**ACTION OF THE PLANNING DIRECTOR**

On November 16, 2006, the Planning Director approved with conditions a Plan Review for three house plans on 105 lots for the project known as Wildflower in the Natomas Central PUD (P06-123). Findings of Fact and conditions of approval for the project are listed on pages 5 through 8

**FILE:** Natomas Central – Wildflower, P06-12~~3~~

Exhibit 2: Plan 251 Floor Plan and Elevations

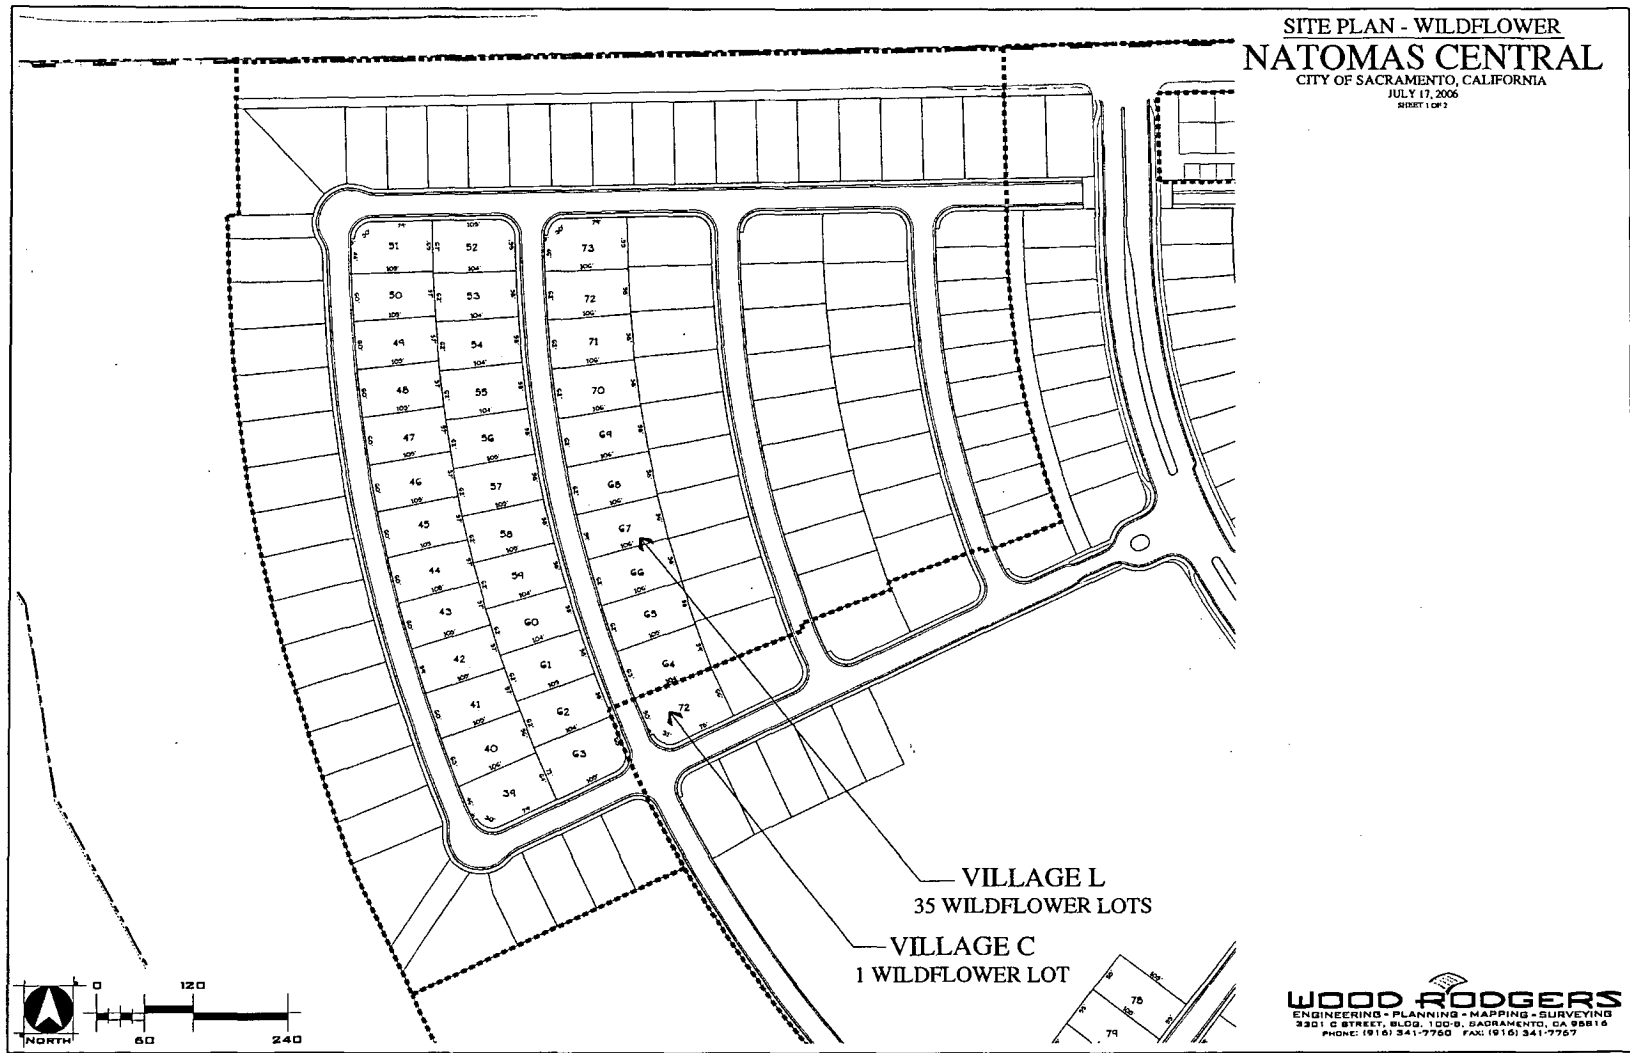
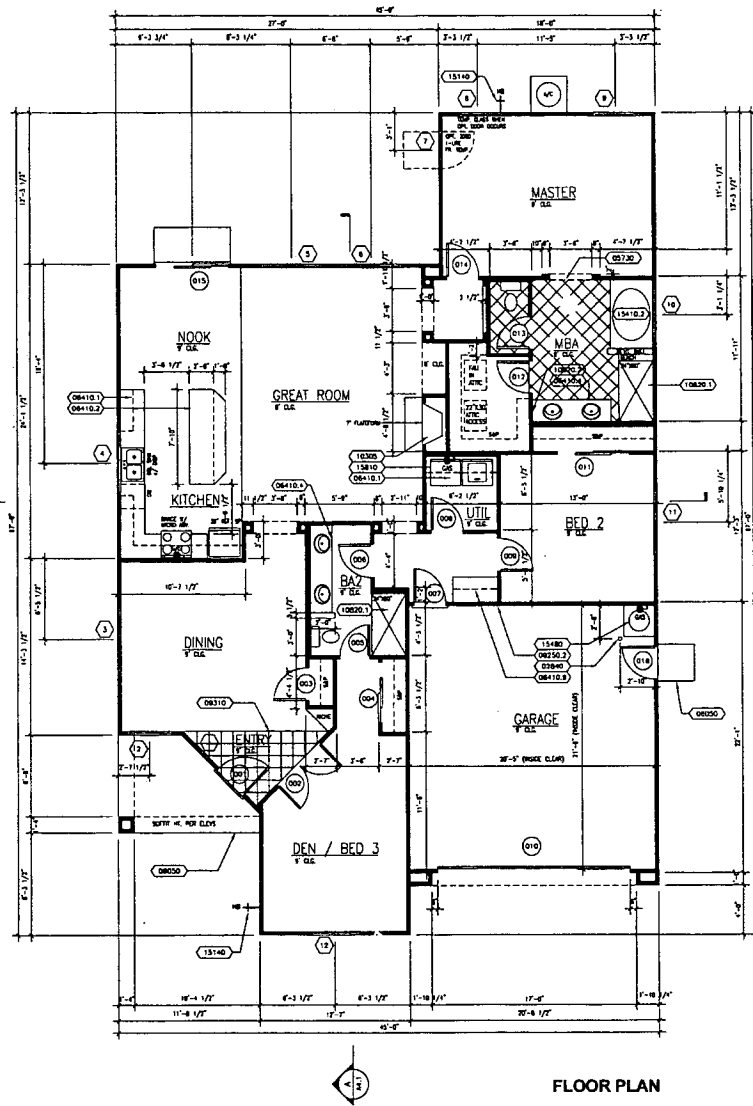
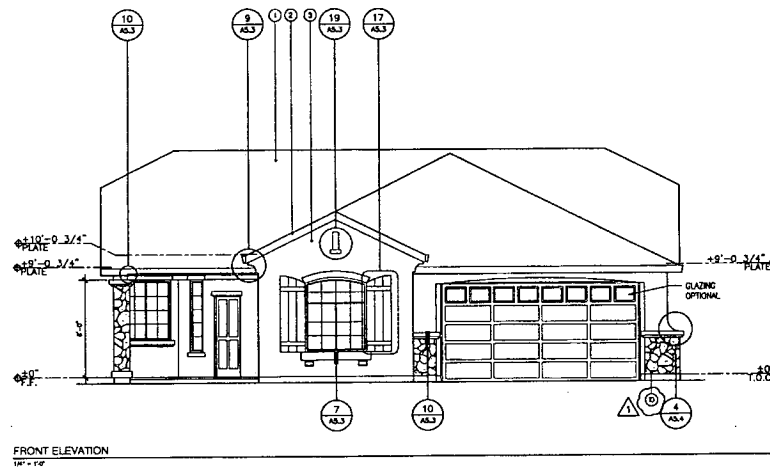
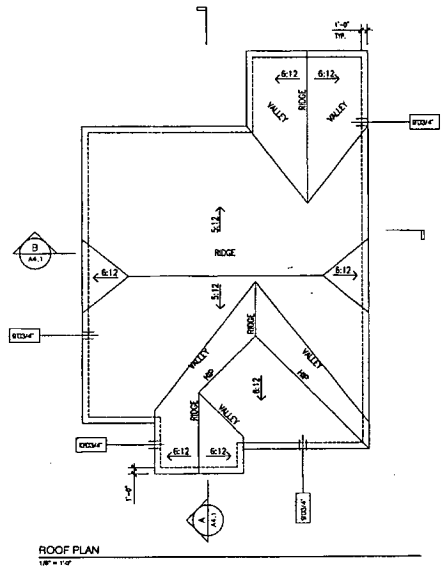
House Plan	Level of Compliance	Comments
Plan 251	Mitigated	Front entry is very recessed, but living space is forward of garage.
Plan 252	Compliant	Front entry is slightly recessed and living space is forward of garage.
Plan 253	Mitigated	Front entry is very recessed, but living space is forward of garage.

- a. The roof pitch shall be consistent throughout Plan 251.
    - b. Stone veneer from the front elevation shall wrap a minimum 4'-0" onto the side elevations. Any reduction in the 4'-0" stone veneer shall be reviewed and approved by the Planning Director.

WILDFLOWER-PLAN 2010  
 ACTIVE ADULT COMMUNITY  
**NATOMAS CENTRAL**  
 CITY OF SACRAMENTO, CALIFORNIA  
 JULY 2006

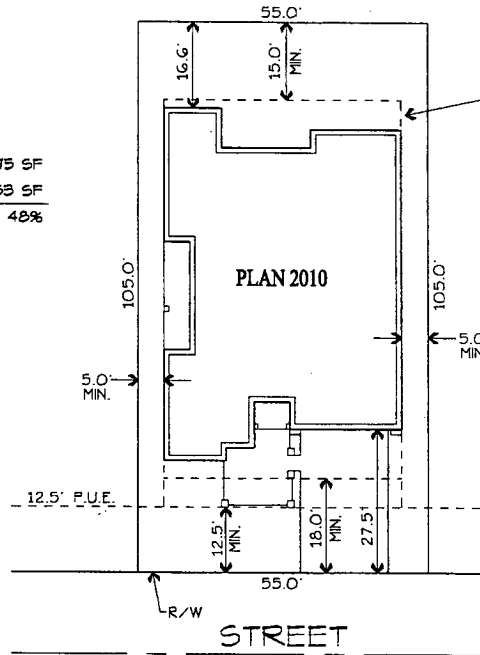
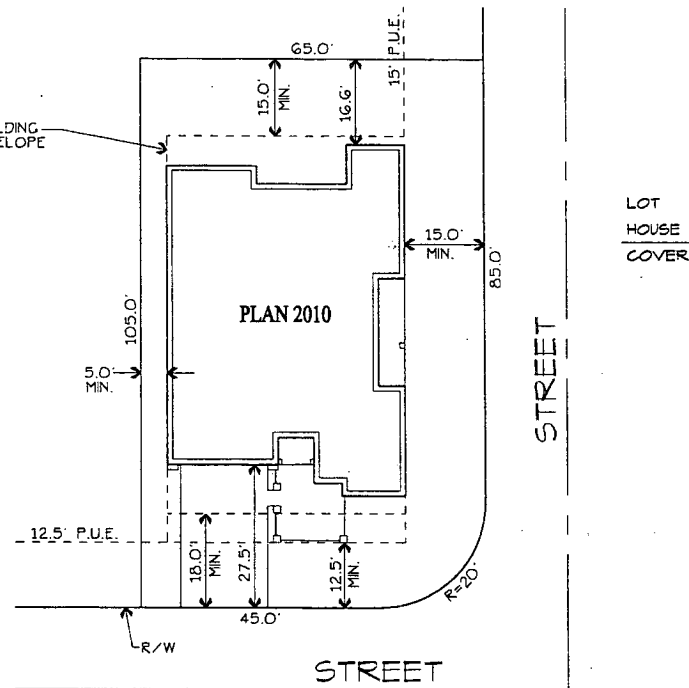
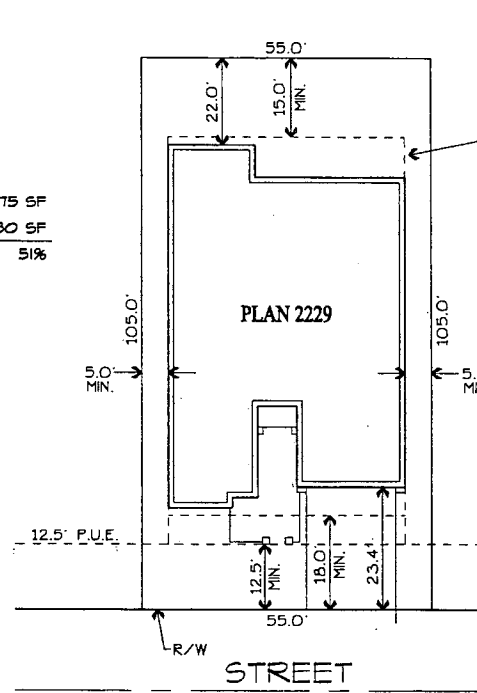
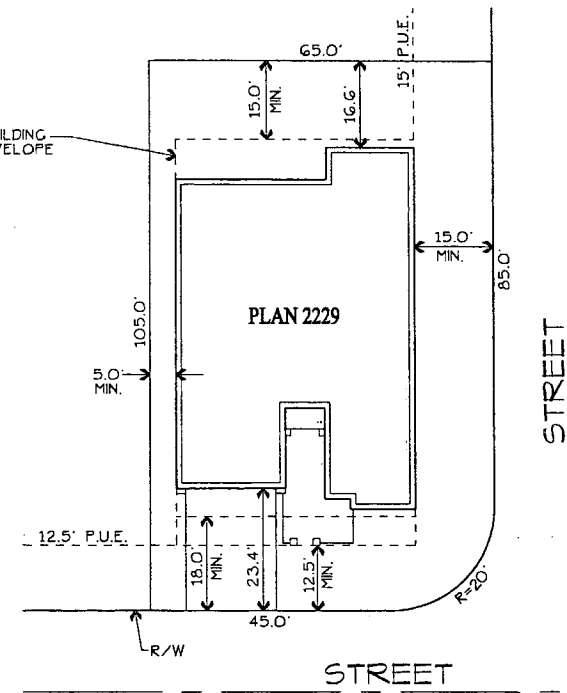
A6. Lot Coverage: Lot coverage shall not exceed 45 percent for single story homes and 40 percent for two story homes, given the following allowances/incentives (also described in the Natomas Central PUD Guidelines under single family housing - conventional shape lots):

- Covered porches in the front or street side do not count toward the maximum lot coverage.
- Attached or detached garages that are recessed a minimum of four feet from the living area of the home (not the porch) count 50 percent toward the maximum lot coverage.
- At the homeowner's discretion, an additional 100 square feet of accessory structure(s) may be built on the lot.
- A maximum of 50 percent of the lots within the Wildflower proposal may exceed the 40 percent lot coverage.
- A maximum of 10 percent of the lots within the Wildflower proposal may have lot coverage for single story homes not exceeding 48 percent with the applicable allowances for covered porch, recessed garage, and accessory structures.
- No more than two (2) homes exceeding the lot coverage shall be located in a row along the street.
